IMPORTANT SAFETY RECALL – SN606

Safety Recall Notice 13V-

SN-606-13

SUBJECT: Platform leveling arm

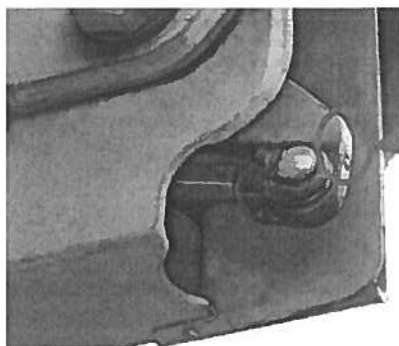
Terex Utilities has received notifications that a structural fatigue crack has been found in some older OM series leveling arms built from 1998 to 2005. The leveling arm keeps the platform level during operation. **Failure of the level arm may result in unintended platform tilting, collision, and occupants falling from the platform.**

This safety notice requires the inspection of the leveling arm, at the elbow, for any cracks specifically in the area indicated below.

Clean and inspect
this area of arm

1. Clean the area around the grease zerk on each side and visually inspect for cracks. If required use an approved NDT inspection method such as dye penetrant.
2. If a crack is found: Contact Terex Utilities, at the phone number or email shown below and provide the aerial serial number and your contact information to arrange repairs. Remove the machine from service until repairs are completed.
3. If no crack is detected: Contact Terex Utilities; through your nearest TEREX Utilities dealer as shown on the web site, terexutilities.com, call Terex Utilities at 605-884-3892 or by email at utilities.warranty@terex.com to arrange for repair within 30 days of receiving this bulletin.

Machines affected by this safety notice may remain in service provided the leveling arm is inspected, for cracks, before and after each working shift until this safety notice is completed.

Dealers and Installers: A letter is being sent to owners of affected units. If affected units are in your area TEREX Utilities will contact you to arrange the repairs. Field Service kit Z1264 will be provided to the nearest Terex Utilities dealer or Field Service Technician for installation.
